HORSESHOE LAKE 2ND ADDITION

Re: S/D 98-4 -- Final Plat of HORSESHOE LAKE 2ND ADDITION

CASE NUMBER: S/D 98-4 - HORSESHOE LAKE 2ND ADDITION

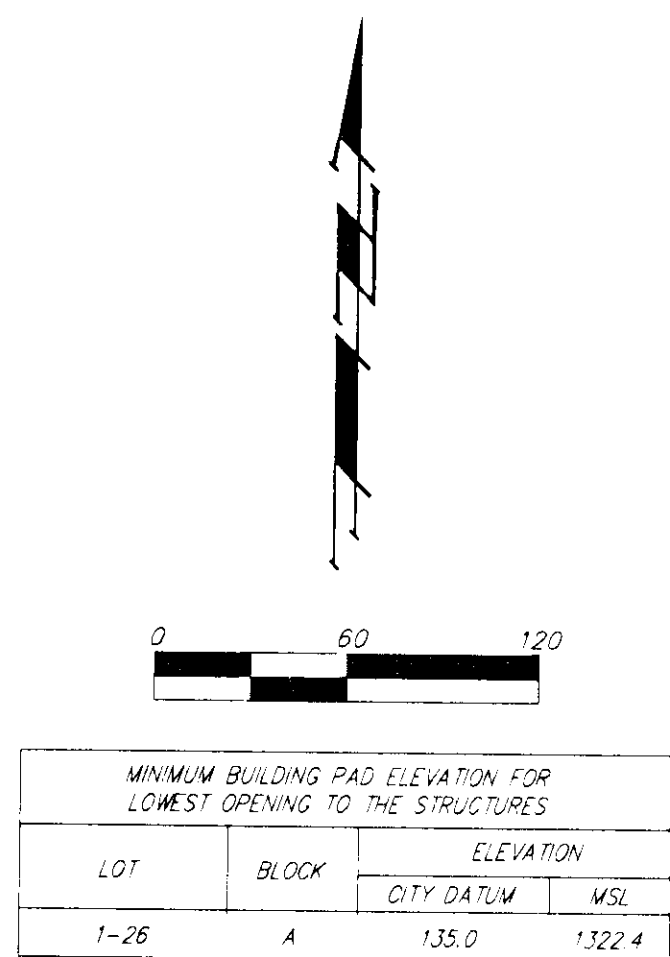
- A. City Engineering needs to indicate if guarantees are required for sanitary sewer or City water to serve this site. City Engineering has requested that easements be increased to 25 feet when shared by sanitary sewer, storm sewer and other utilities.

- C. City Engineering needs to comment on the status of the applicant's drainage plan. The drainage plan is approved. Wherever storm sewer, sanitary sewer and other utilities share an easement, it is requested that the width of the easement be increased to 25 feet.

- F. Since this plat proposes the platting of narrow street right-of-way with adjacent "15-foot drainage and utility easements", a restrictive covenant shall be submitted which calls out restrictions for lot owner use of these easements. Retaining walls and change of grade shall be prohibited within these easements as well as fences, earth berms and mass plantings.

- I. Traffic Engineering needs to comment on the need for any improvements to perimeter streets. *Traffic Engineering has requested the elimination of the turnaround at the end of the existing street for safety reasons. Applicant desires to maintain the cul-de-sac to provide a separation between the commercial and residential uses.*

- J. Fire Department needs to comment on the acceptability of the cul-de-sac access. Lakeway Court (approx. 650 feet) exceeds the maximum length of 600 feet as specified in the Subdivision regulations. *The street length is acceptable due to topographical constraints.*

- L, Fire Department needs to comment on the acceptability of the street names. *The names of Lakeway Court and Lakeway Circle should be transposed.* The final plat has denoted said revision.

- S. The representatives from the utility companies should be prepared to comment on the need for any additional utility easements to be platted on this property. The representatives from Southwestern Bell and KGE have requested additional easements. The easements have been denoted on the final plat.

- U. "Section 24" should be corrected to read "section 3" in the surveyor's certification.
- V. Unified maintenance of the adjoining lake in Reserve F of the Horseshoe Lake Addition should occur; consisting of homeowners in both Additions.

- X. On the final plat tracing, a note shall be placed on the face of the plat indicating that this Addition is subject to the conditions of Community Unit Plan DP-75 Amendment #1.

At the regular meeting of the MAPC on March 12, 1998, the above-captioned plat was considered. The action of the Planning Commission was to recommend that the plat be approved as recommended by the Subdivision Committee subject to conditions stated in our letter of March 6, 1998, with the exception of Item I. Item I shall be replaced with the following:

- A. The existing turnaround at the end of the existing street be retained,
- B. ~~A stop sign be posted north of the existing cul-de-sac for southbound~~
~~traffic,~~
- C. A No Outlet sign be posted on Lakeway Circle, and
- D. No Parking Signs shall be posted within the existing cul-de-sac.

- The Subdivision Committee required the following: a) the existing turnaround be maintained, b) a 15-mph sign be posted 200-ft south of the existing cul-de-sac, c) A stop sign be posted at the existing cul-de-sac, d) A No Outlet sign be posted on 21st St., and e) A No Parking sign be posted within the existing cul-de-sac.*
